Subject ▶ Changes on Slider Support and Relative Parts

For Models ▶ JR3020(Recipro saw)

* *Details of Changes on Parts in Fig. 1* * (See List 1 about each part No. of the current/the new.)

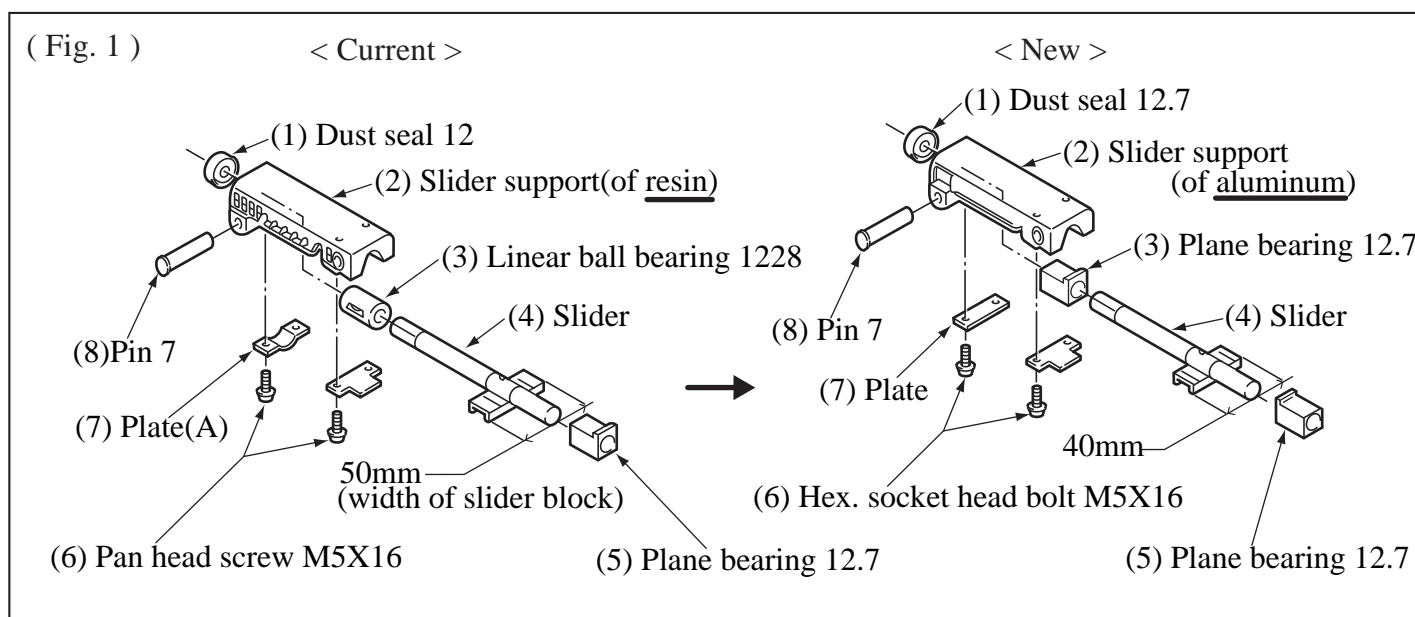
Description ▶ As in the following Fig.1 and "Details of Changes"

Part name	Change in	Current	New
(1) Dust seal	Inner diameter	11 mm (7/16")	11.7 mm (29/64")
Note : There's a tiny circle raised on the new dust seal 12.7 for distinction from the current dust seal.			
(2) Slider support	Material	Resin	Aluminum
(3) Bearing to hold the slider	Shape	Linear ball bearing 1228(tube type)	Plane bearing 12.7 (block type)
(4) Slider	1) Width of "slider block"	50 mm (1-31/32")	40 mm (1-37/64")
	2) Outer diameter	12 mm (15/32")	12.7 mm (1/2")
(5) Plane bearing 12.7	Setting direction	In modified machines, this bearing is turned round as in Fig. 1; remark the position of protrusion of its upper side. (Bearing itself remains the identical)	
(6) Screws to fix the plate	Shape	Pan head screw	Socket head bolt
(7) Plate to hold the bearing	Shape	Curved type	Flat type
(8) Pin 7	Hardness	The new pin is harder than the current.

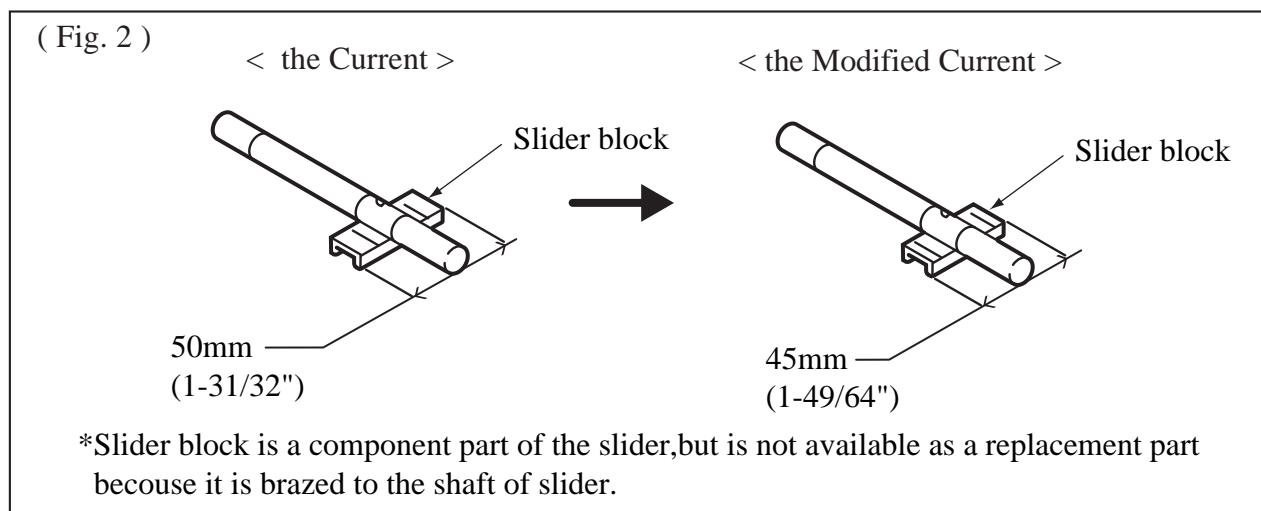
The Following modification in Fig.2 has been implemented on the current slider although its part No. remains the same (168268-5).

Be sure to use only the "modified current slider" for replacement of the current slider.

On receipt of "the modified current slider", which has been available since July 1995, your stock of "the current" should be abandoned in order not to let your stock be in confusion.
